RE: Bloomfield Refining Company
#50 County Road 4990
Bloomfield, New Mexico
EPA ID No. NM089416416
Administrative Order on Consent - Docket No. VI-303-H
Response to USEPA Comments on the Draft RFI/CMS Report

**RESPONSE TO USEPA COMMENTS ON THE 11/08/94 DRAFT RFI/CMS REPORT
BLOOMFIELD REFINING COMPANY**

DESIGNED BY:	DRAFTED BY:	CHECKED BY:	
RS	PJWH		
DATE:	FILE:		
04/03/95	MW-LOCA1		
PROJECT NO.:	CONTRACT:		
023353014			
DRAWING:	REVISION:		
FIGURE 1

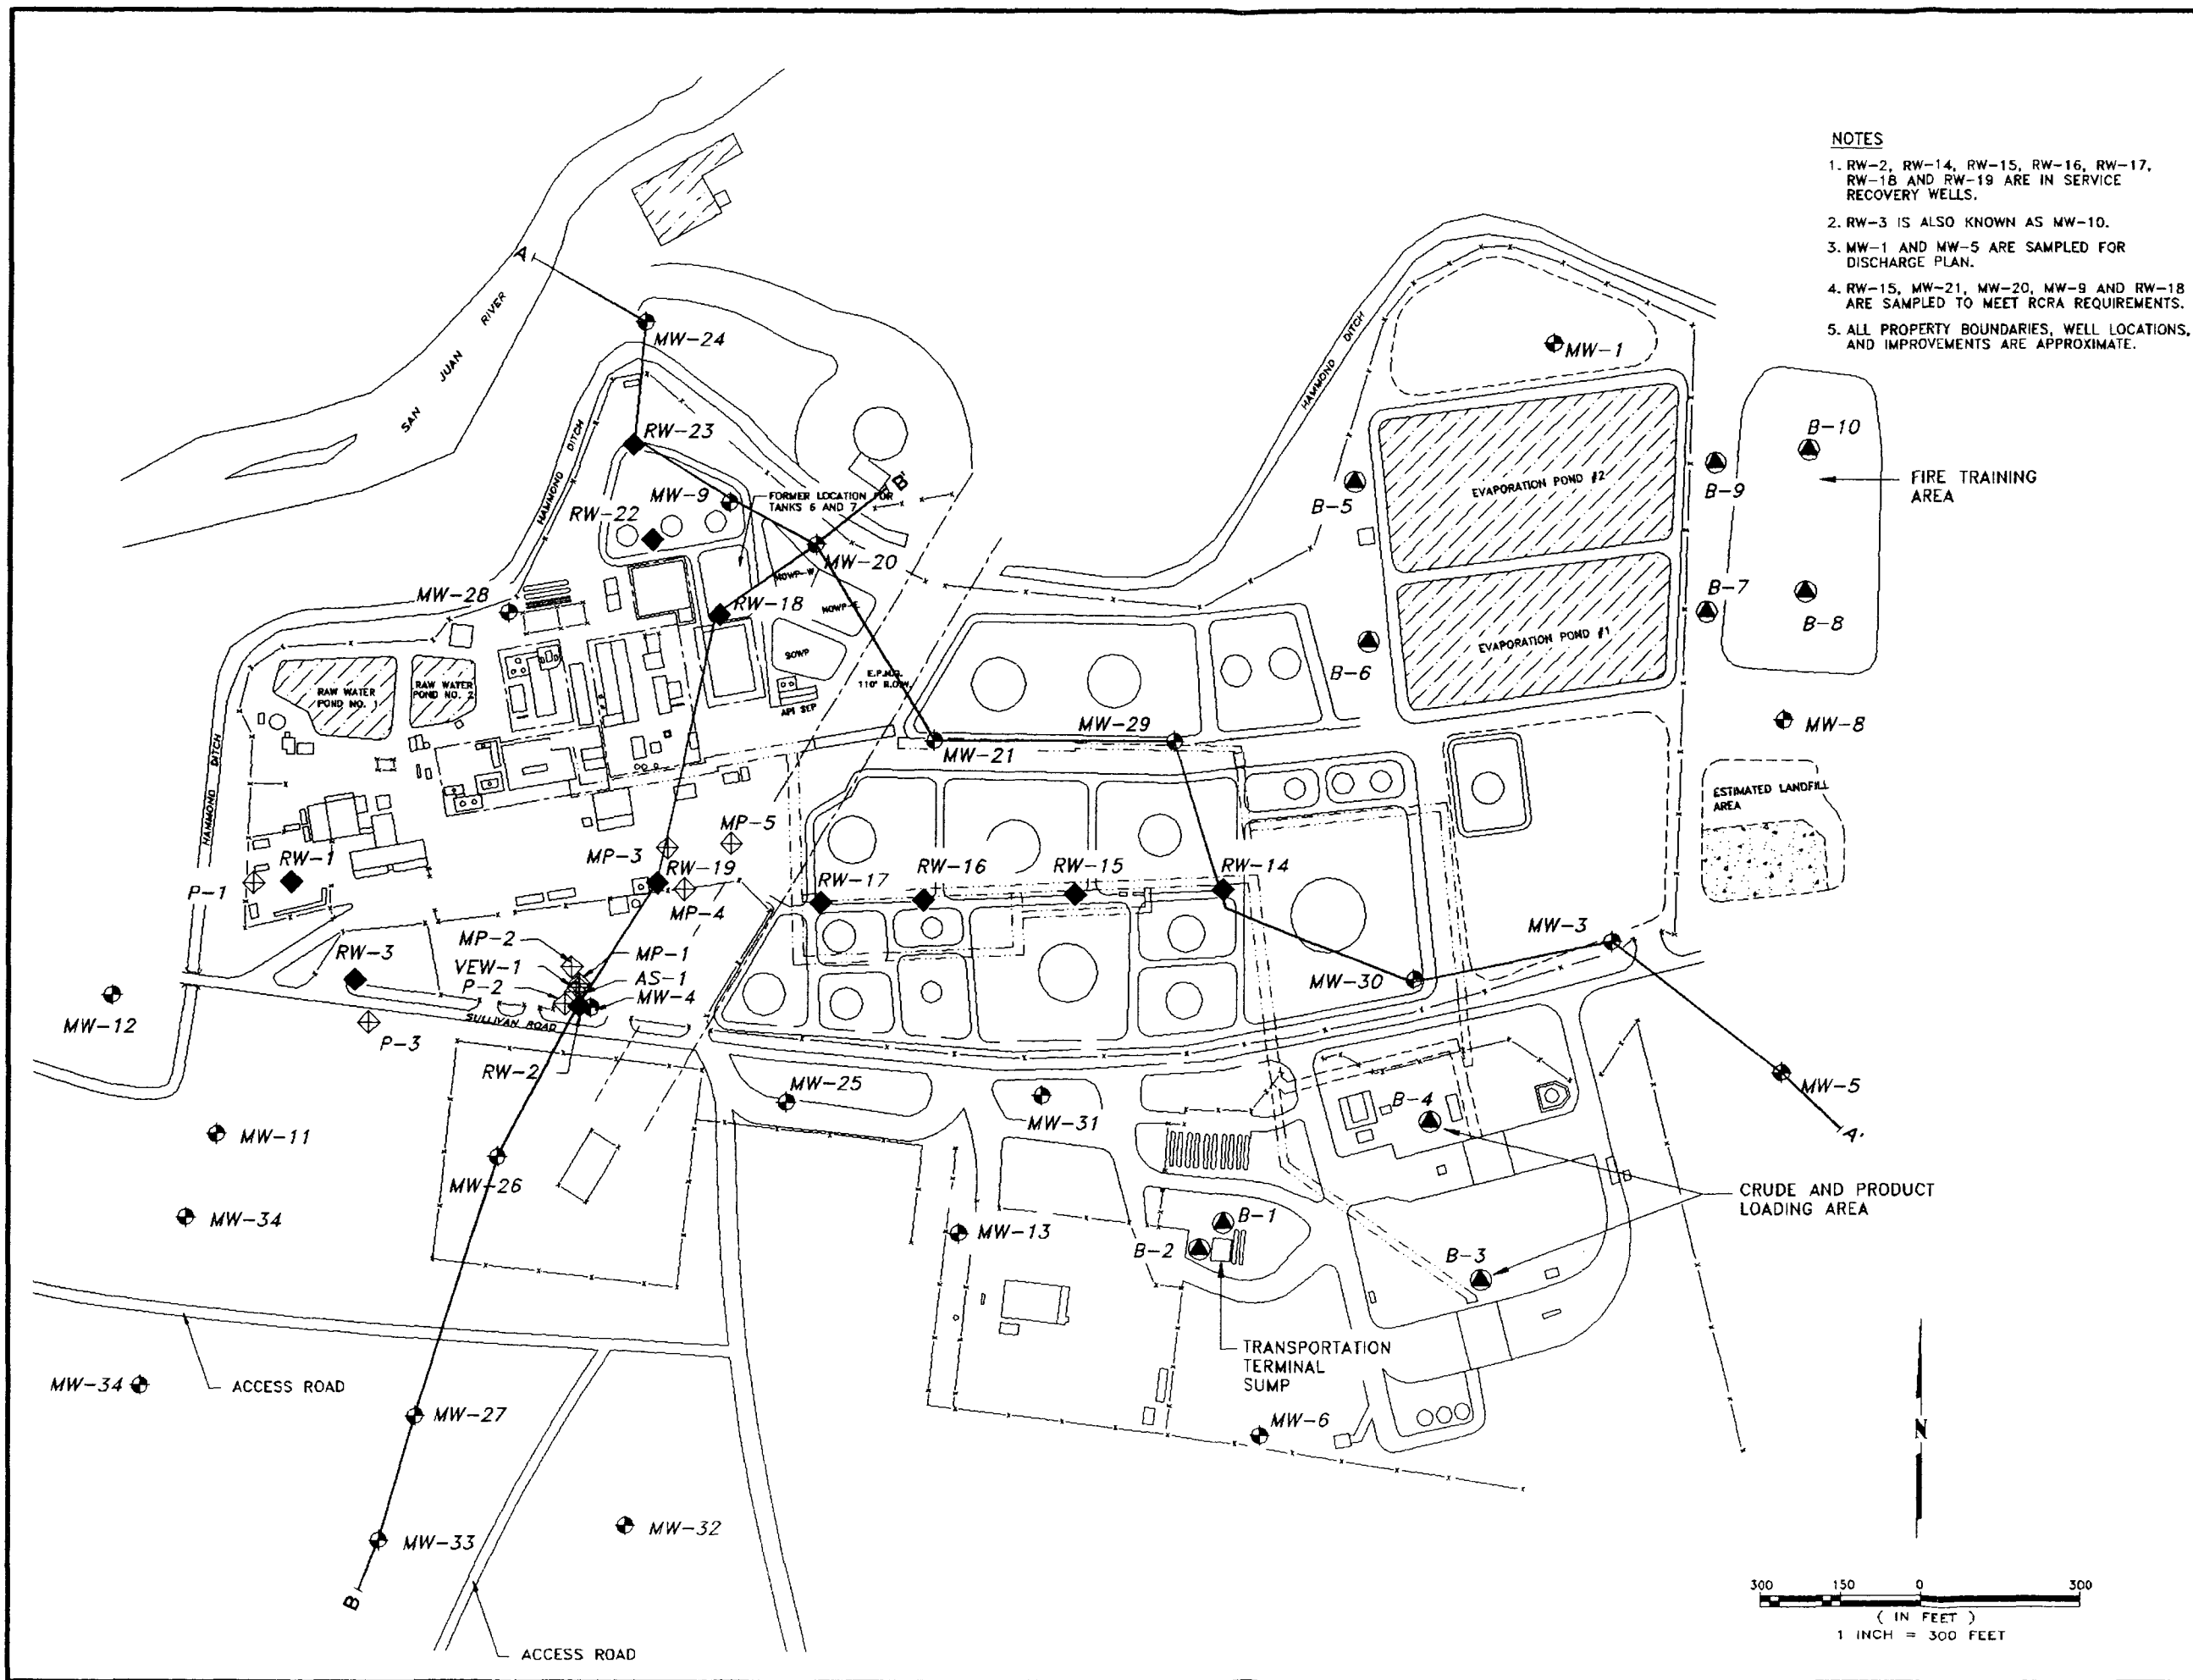
The draft RFI report does not contain any cross sections depicting subsurface geology. As such, the subsurface stratigraphy is difficult to analyze on a site-wide basis. All future submissions must contain the appropriate cross-sections, utilizing available soil borings, recovery wells, and groundwater monitoring wells to adequately characterize subsurface geology.

Response: The locations of the cross sections that have been developed are shown on Figure 1. Cross Section A-A' is shown as Figure 2 and represents a northwest to southeast profile of the site geology and hydrogeology. In general, both the surface topography and the surface of the Nacimiento dip to the west. With the exception of the area around Hammond Ditch, water elevations across the site decrease toward the west and define a relatively shallow, westward trending groundwater gradient. At Hammond Ditch, the saturated zone beneath the ditch is shown as a barrier to the migration of SPH to the north. The primary stratigraphic units in the line of section are clay and silty clay, sand and silty sand, sand with gravels and cobbles, and a gravel/cobble layer. The primary saturated zone across the site is a gravel and cobble layer that is present across much of the site. Cross section B-B' (Figure 3) is a southwest to northwest section through the western area of the facility. Stratigraphic units are similar to those shown on cross section A-A'.

FIGURE 7

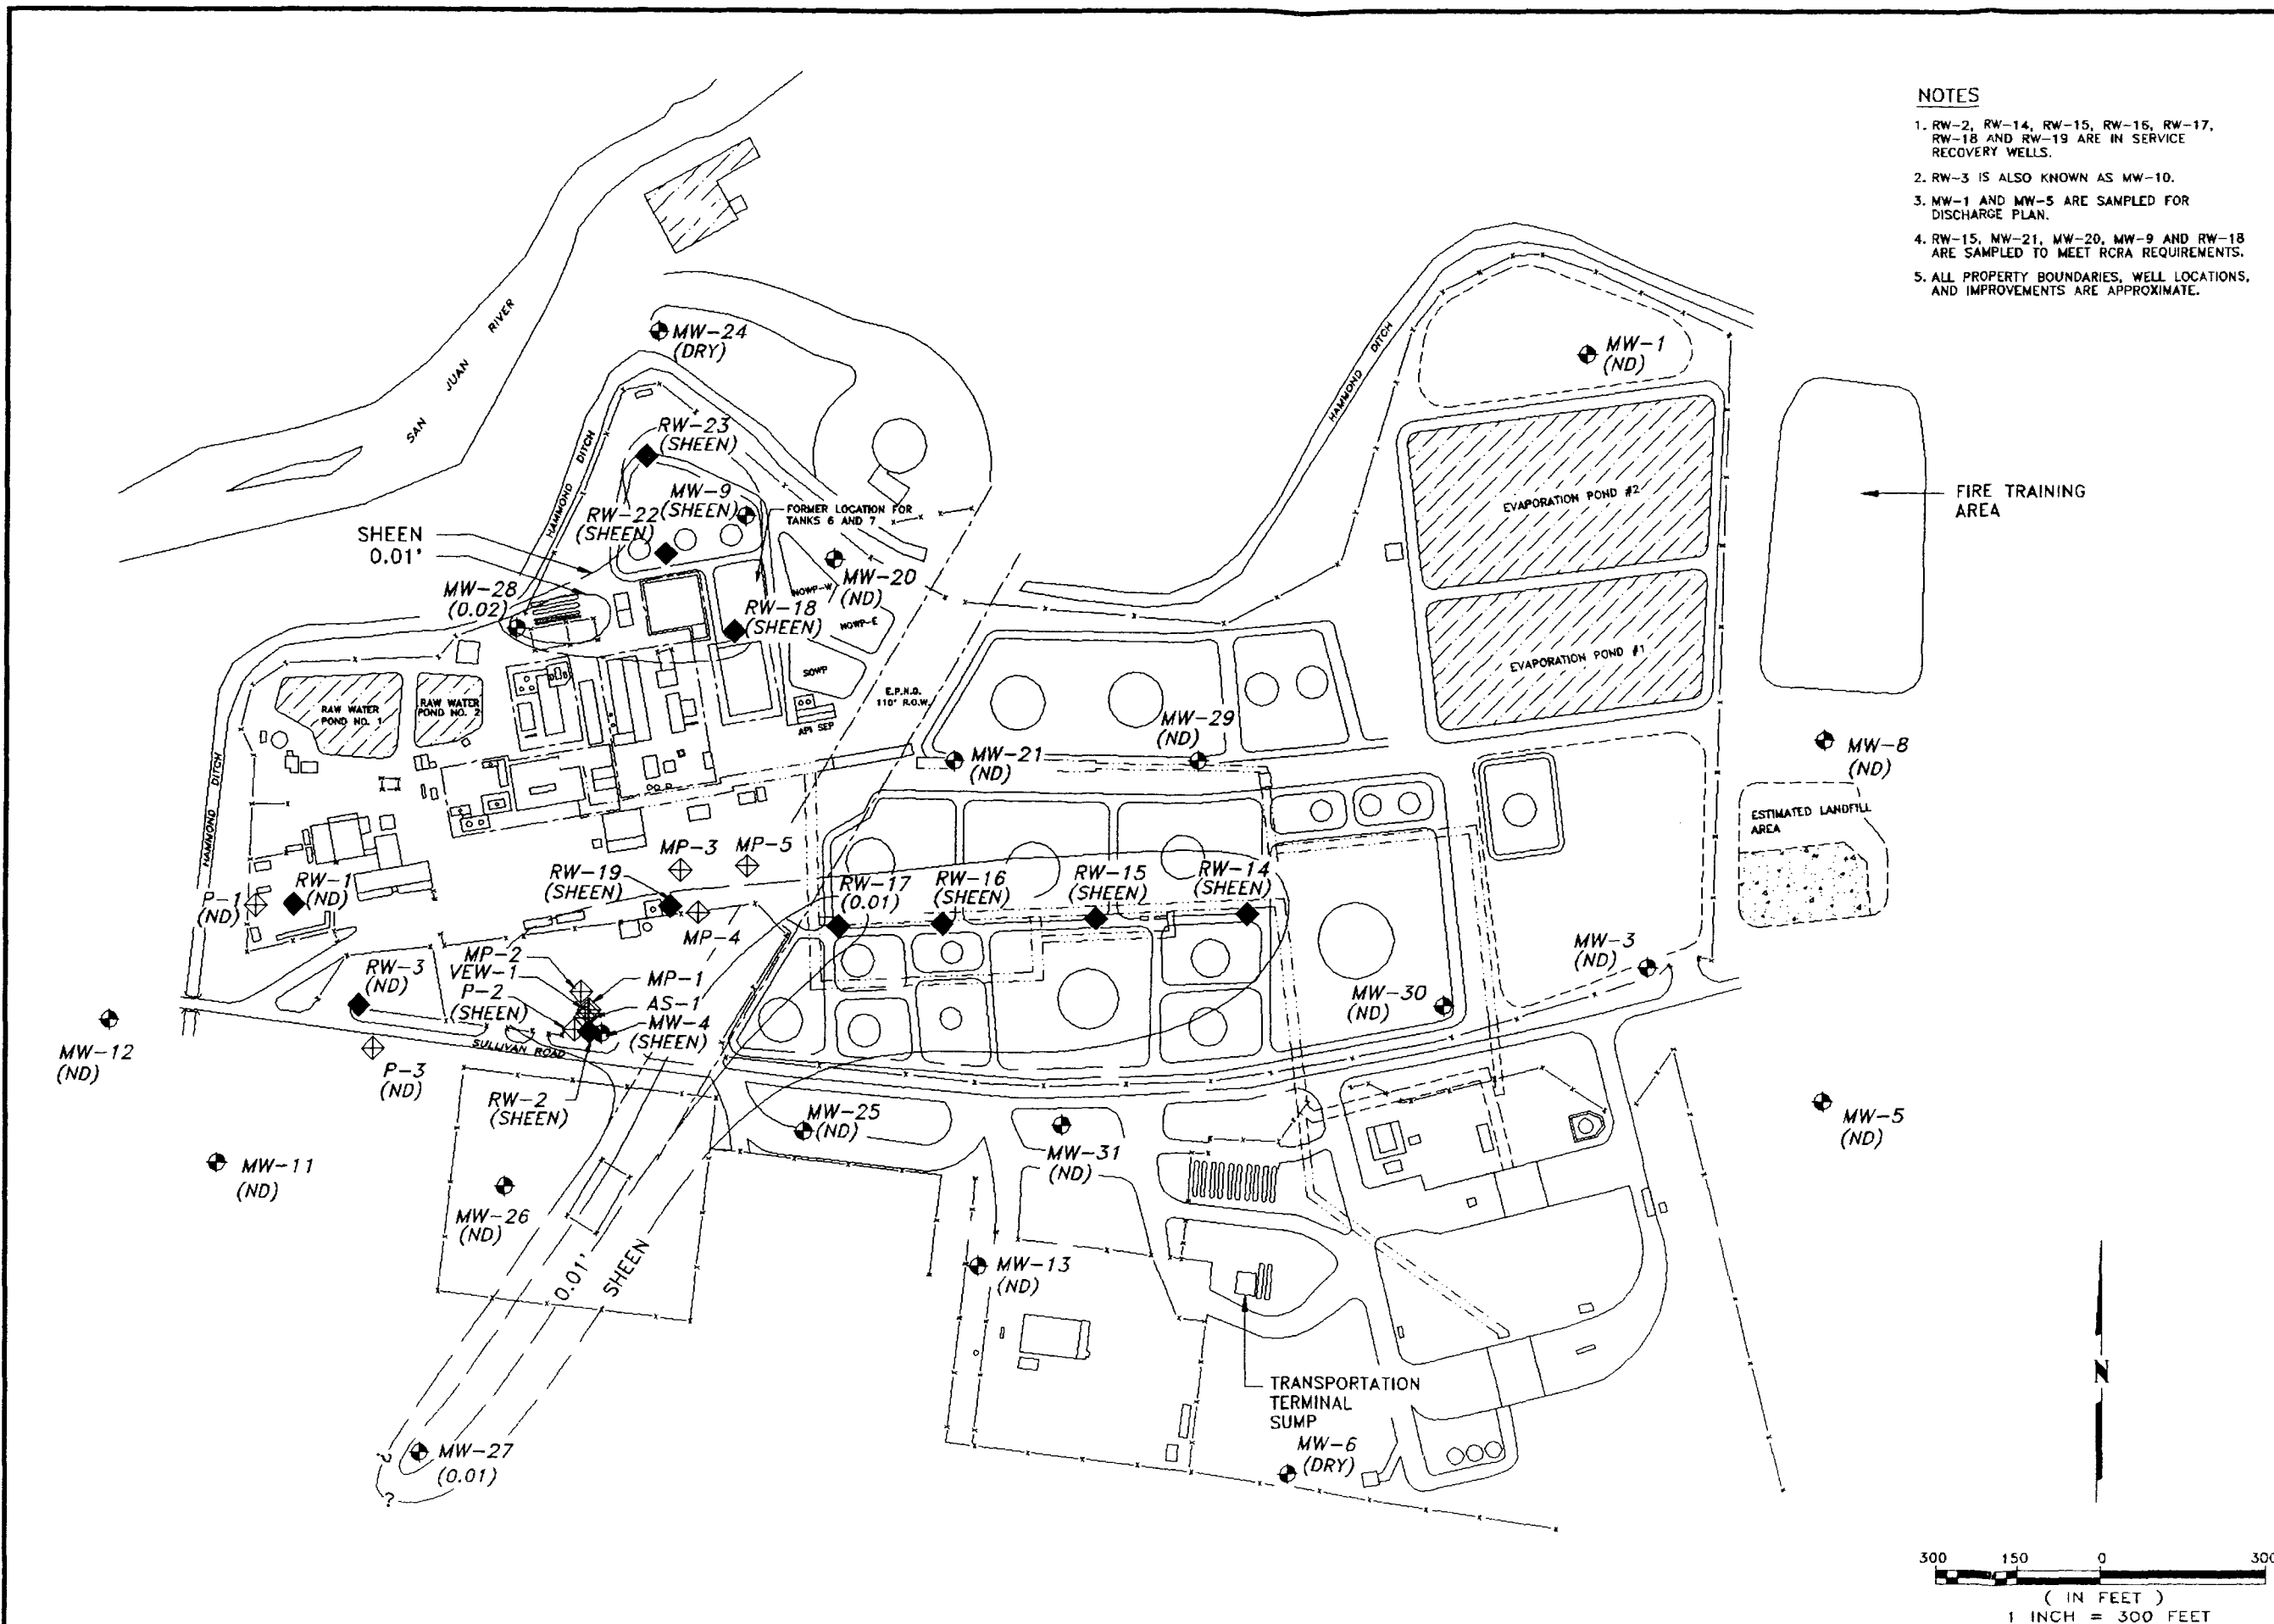
The draft RFI report does not contain any thickness maps showing the limits of groundwater contamination. These maps must be compiled to show the limits of groundwater contamination across the facility as well as off-site.

Figures 4, 5, 6, 7, 8, 9, and 10 depict the extent of SPH, total targeted volatile organics, and total targeted semi-volatile organics, based on the May 24-25, 1994 monitoring data and the August 3-4, 1994 monitoring data. The maps show two main areas of hydrocarbon contamination. Dissolved hydrocarbon and SPH plumes are present along much of the south side of the facility extending southwest along the El Paso Natural Gas pipeline. The levels of SPH in this area are currently controlled by a number of recovery wells. Three additional monitor wells have been installed southwest of the site and plume definition is essentially completed with these wells (the results will be forwarded to USEPA before 1 May 1995). In the northwest corner of the site, another area of hydrocarbon contamination is present. In this area, a thin accumulation of SPH has been identified.
